ES_LPC185x/3x/2x/1x Flash

Errata sheet LPC185x, LPC183x, LPC182x, LPC181x
flash-based devices

Rev. 4 — 23 July 2013

3.4 ISP.1: 'J' command in ISP mode swaps last two items

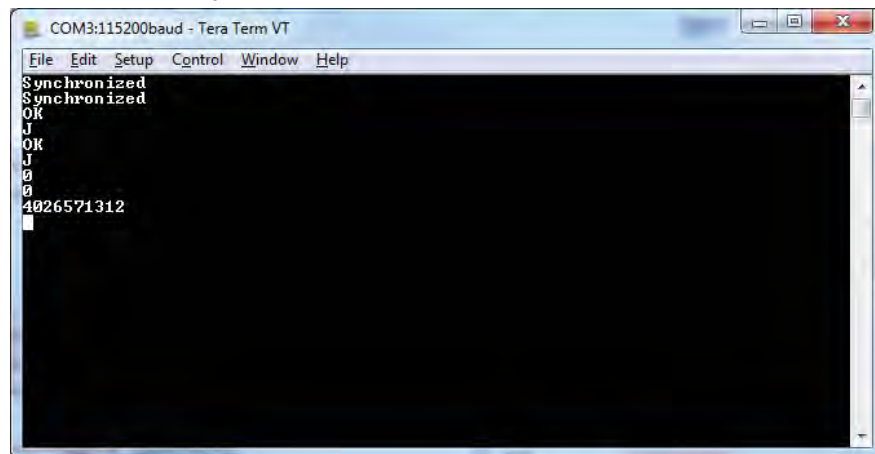
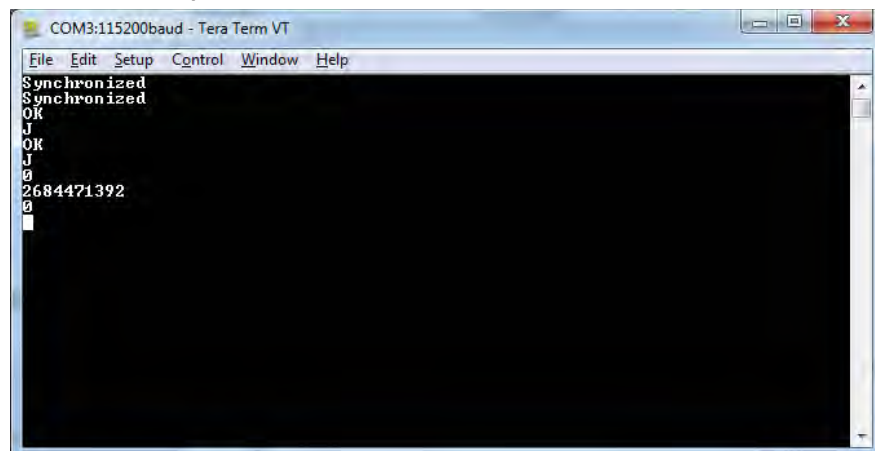
The 'J' command in ISP mode should return an error code, followed by an ASCII string representation of the part ID, followed by a 0. However what is actually returned is the error code, followed by a 0, followed by an ASCII string representation of the part ID. The problem is the last two items returned are swapped.

Incorrect example:

Correct example:

There is no work-around for this problem.

Fig 1. PMC wakeup keep-out area

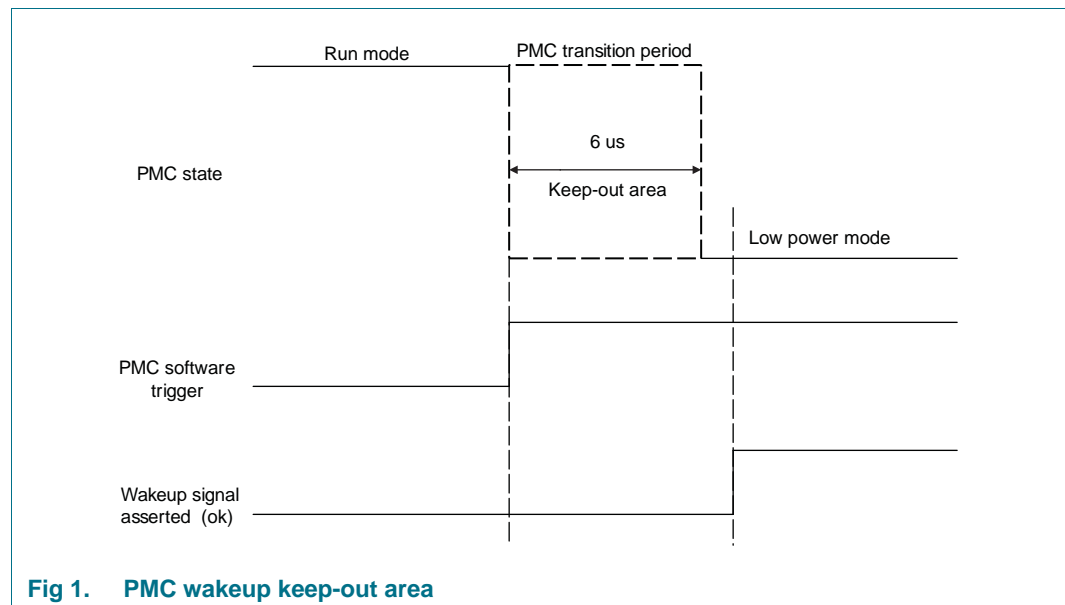
When the chip is in a transition from active to Deep Sleep, Power Down, or Deep Power Down, wakeup events are not captured and they will block further wakeup events from propagating. The time window for this transition is 6 μ s and is not affected by the chip clock speed. After a wakeup event is received during the PMC transition, the chip can only recover by using an external hardware reset or by cycling power.

Make sure that a wakeup signal is not received during the Deep Sleep, Power Down, or Deep Power Down transition period. An example circuit to work around this could include an external 6 μ s one shot which could be triggered via software using a GPIO line when entering Deep Sleep, Power Down, or Deep Power Down mode. The one-shot's output could be used to gate the wakeup signal(s) to prevent receiving a wakeup signal during the PMC transition period. Depending on the system design, it may also be needed to latch the wakeup signal(s) so that they will still be present after the one-shot's 6 μ s timeout.

3.8 USB.1: The USB controller USB0 is unable to communicate with a low-speed USB peripheral in host mode when using full-speed hub

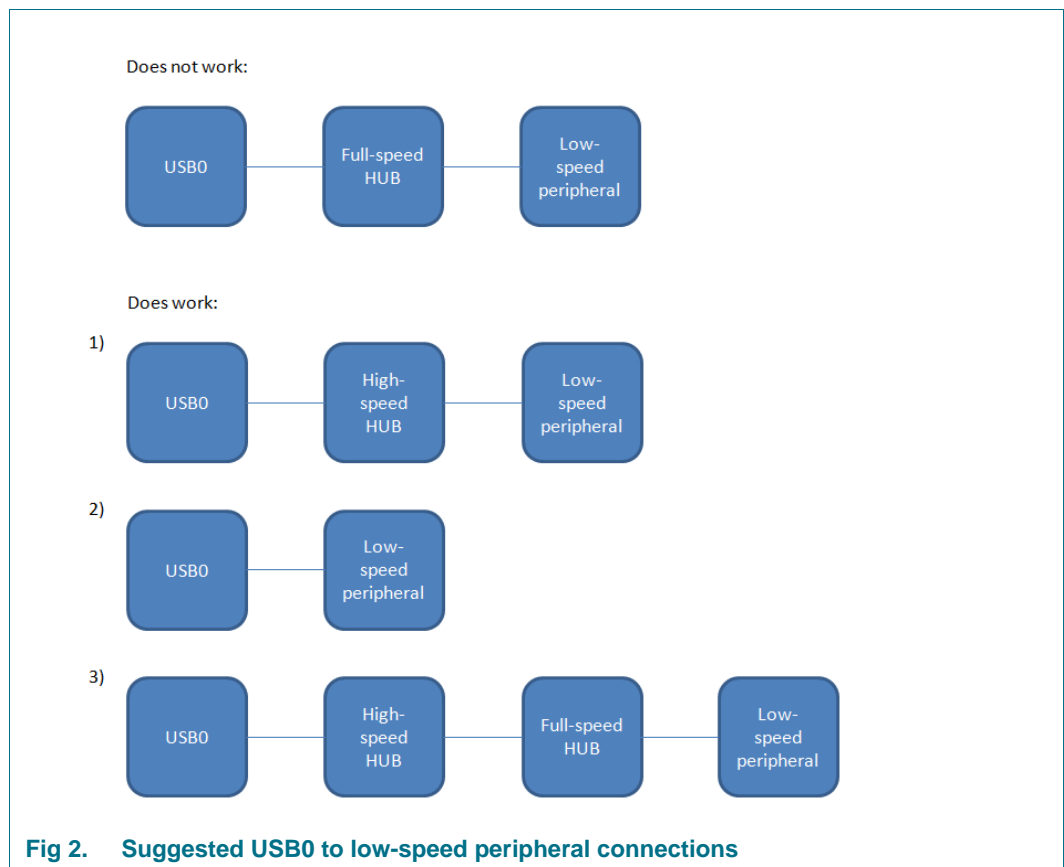
The USB controller called USB0 is unable to communicate with a low-speed USB peripheral in host mode when there is a full-speed hub directly connected to the USB0 port and a low-speed peripheral is connected in the tree somewhere below this full-speed hub. Only USB0 has this problem; the other USB controller, USB1 does not.

There is no work-around for this problem. It is suggested that the low-speed USB peripheral is either connected directly to USB0 or a high-speed hub is placed between that peripheral and USB0.
